Palo Verde Nuclear Generating Station
5801 S. Wintersburg Road
Tonopah, AZ 85354-7529

102-07975-CS/MA
August 30, 2019

**Subject: Palo Verde Nuclear Generating Station (PVNGS)
Units 1, 2, and 3 and Independent Spent Fuel Storage
Installation
Docket Nos. 50-528, 50-529, 50-530 and 72-44
License Nos. NPF-41, NPF-51 and NPF-74
PVNGS Emergency Plan, Revision 64**

PVNGS Emergency Plan, Revision 64

FIGURE 7 STATE, COUNTY & LOCAL EMERGENCY OPERATIONS CENTER ORGANIZATION

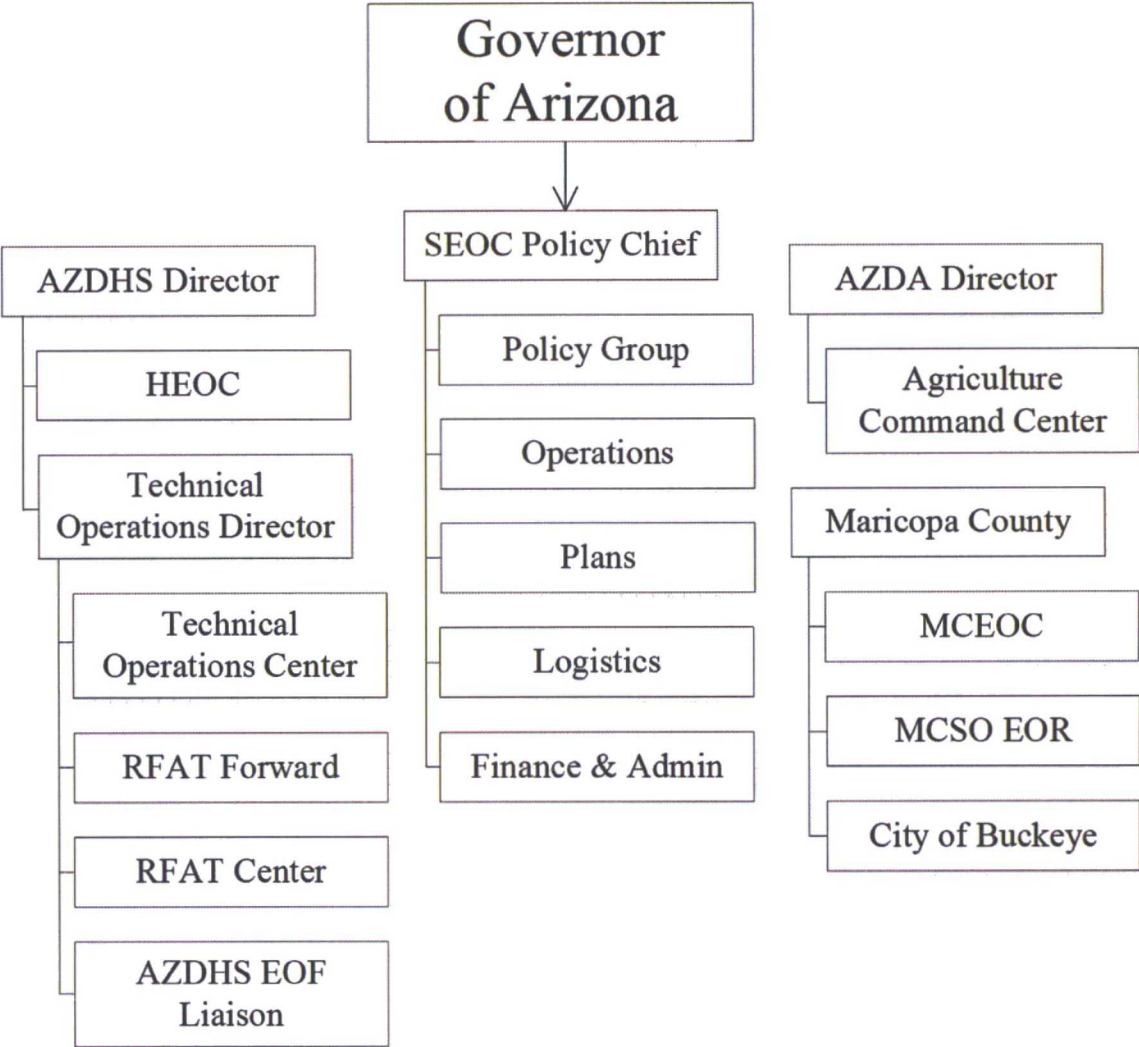
48, Figure 7	Updated Figure 7 to reflect new reporting structure.
56, Step 6.7.1.1	Changed onsite protective of employees to "Onsite protection of employees..." for better readability
71, Step 7.2	Corrected bulleted column breaks so they read 1) Radiological Assessment Coordinator 2) Radiological Assessment Coordinator.
71, Step 7.2.2	Changed to "The Environmental Assessment Line has a dedicated primary and backup line providing communications links with conference capability between the TSC, EOF, the Control Room and the RSP.
72, Step 7.2.7	Changed to "The Radiological Line has a dedicated primary line providing communications links with conference capability between the RP Office, TSC, Control Room, STSC, the OSC, and the RSP.
75, Step 7.2.28	Changed to "Water Resources."
74, 75, 77, 78, 103	Changed ADEM to DEMA here and throughout the document
82, Step 7.3.1.8	Changed section title from Portable Survey Instruments to "Qualified Safety Parameter Display System (QSPDS)"

Current Revision	Organization chart led by policy Group – Governor Chairman, Maricopa County Board of Supervisors Director ADEM AZ Homeland Security
Change Page 48, Figure 7	Organization chart led by Governor of Arizona
EP Function	10 CFR 50.47(b)(3)
Effectiveness Review/Conclusion	This change is not a reduction in effectiveness of the Palo Verde Emergency Plan because it consolidates and minimizes confusion of the organization under the Governor of Arizona. The change has no impact on the associated planning standard or EP Function.
Change Summary	Changed the word from “protective” to “protection” for clarity
Current Revision	Onsite protective of employees during a hostile action involves a combination of restricted movement, movement to safe locations, and site evacuation depending on the nature of the hostile event and advance warning.
Change Page 56, Step 6.7.1.1	Onsite protection of employees during a hostile action involves a combination of restricted movement, movement to safe locations, and site evacuation depending on the nature of the hostile event and advance warning.

**FIGURE 12 DEMOGRAPHY WITHIN THE PLUME EXPOSURE PATHWAY
EMERGENCY PLANNING ZONE**

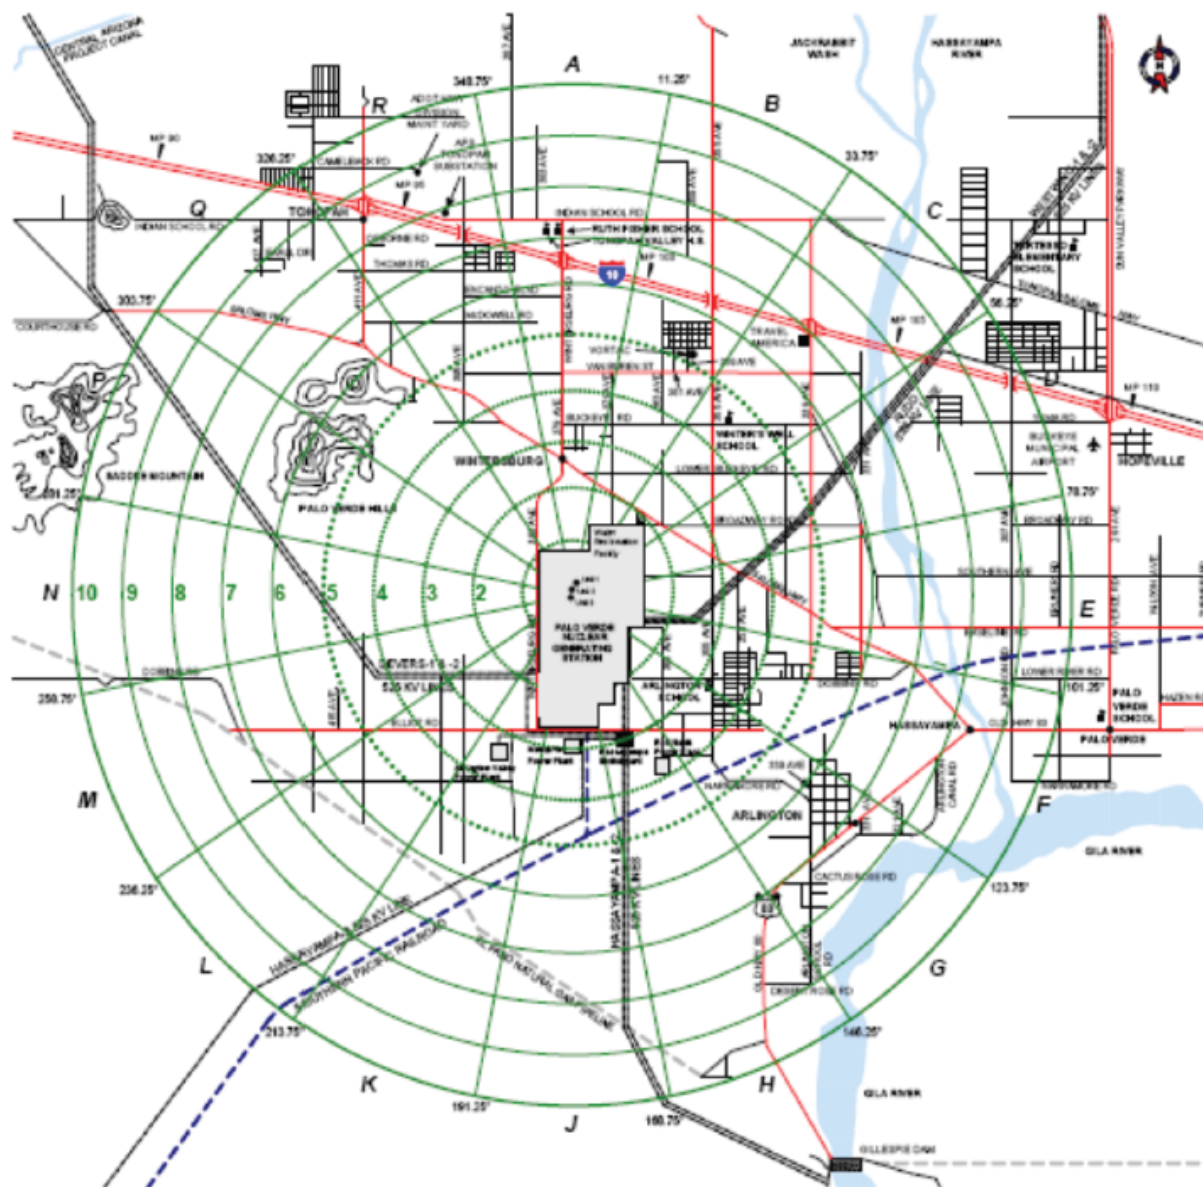
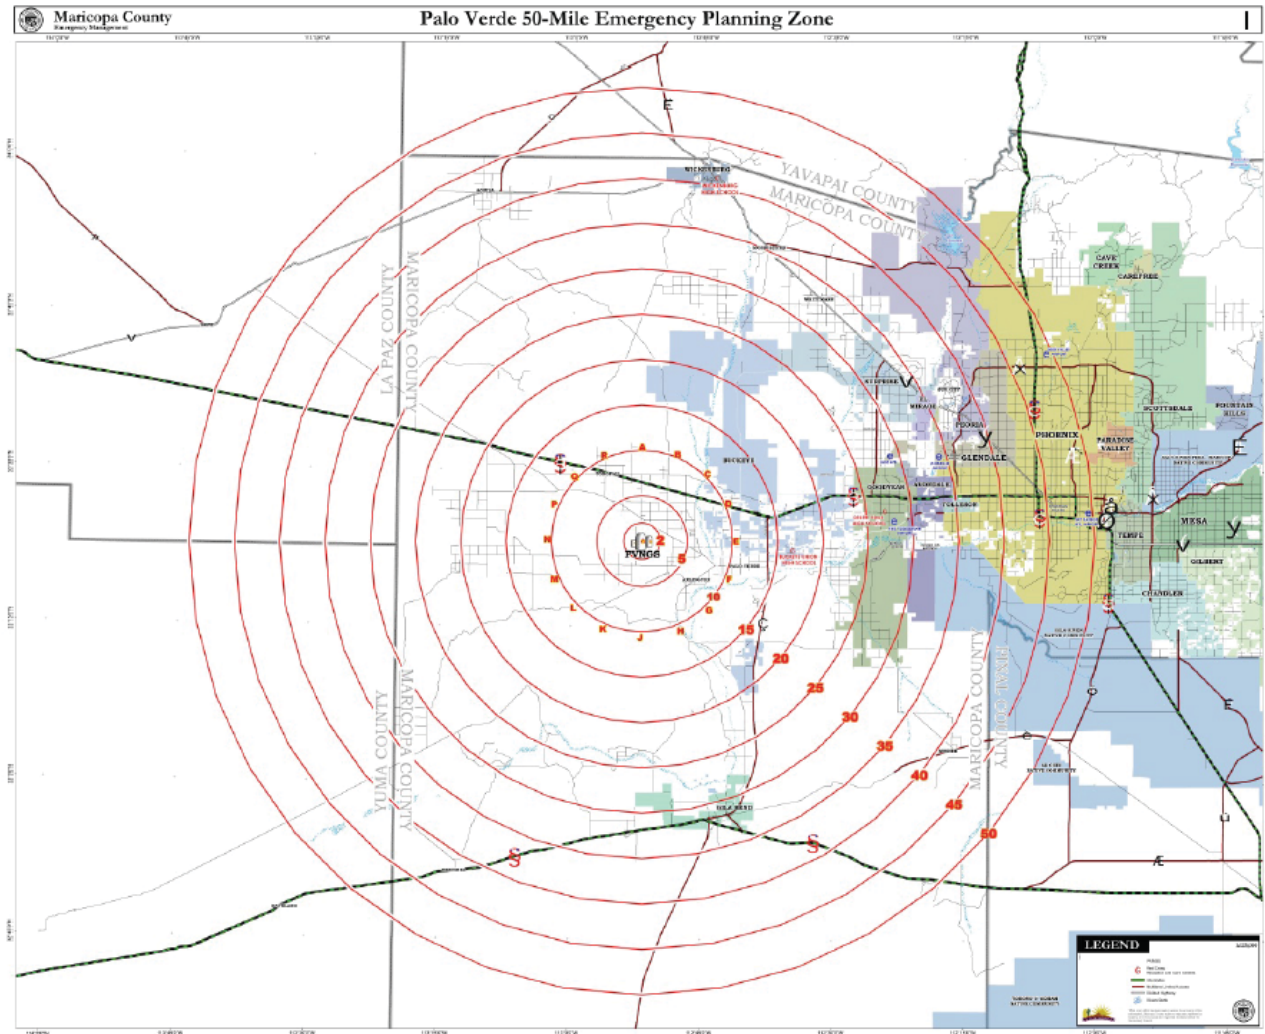
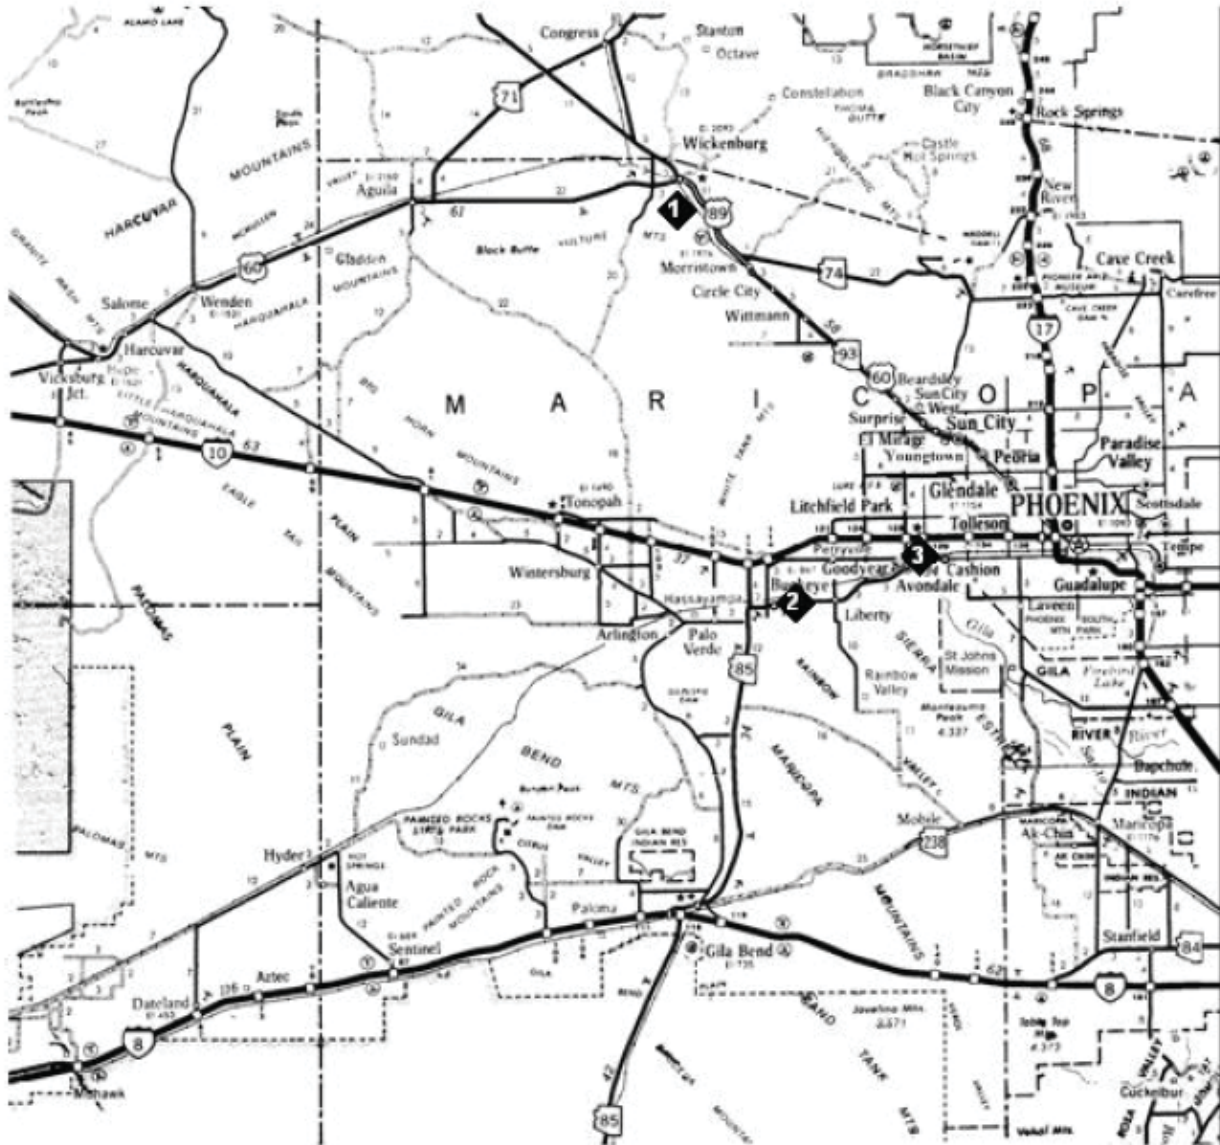
EP Function	10 CFR 50.47(b)(3)
Effectiveness Review/Conclusion	This change is not a reduction in effectiveness of the Palo Verde Emergency Plan.
Change Summary	Updated October 2017 data within the Demography Within the Plume Exposure Pathway Emergency Planning Zone chart to current November 2018 data
Current Revision	Palo Verde Population Survey – October 2017
Change Page 107, Figure 12	Palo Verde Population Survey – November 2018
EP Function	10 CFR 50.47(b)(10)
Effectiveness Review/Conclusion	This change is not a reduction in effectiveness of the Palo Verde Emergency Plan because it adds the most current demography numbers.
Change Summary	Cross reference to NUREG 0654 Section 16 updated
